PRODUCT UPGRADE NOTIFICATION:

Effective 2022, the paper dispenser in our SWAR module and the Behind-the-mirror products will be supplied as shown in the picture below

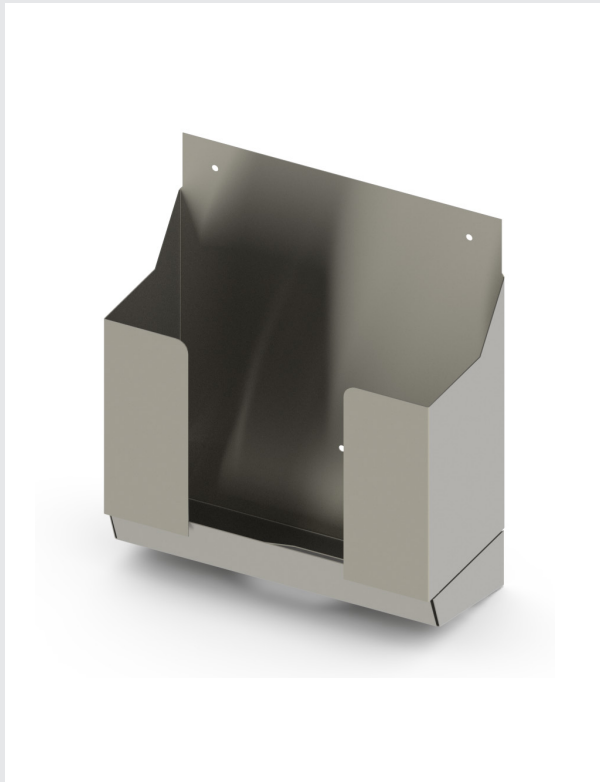
The new product has undergone several upgrades:

- Capacity: The dispenser can now hold double the amount of paper despite remaining the same height
- Based on 316-Stainless-steel
- Increase in thickness
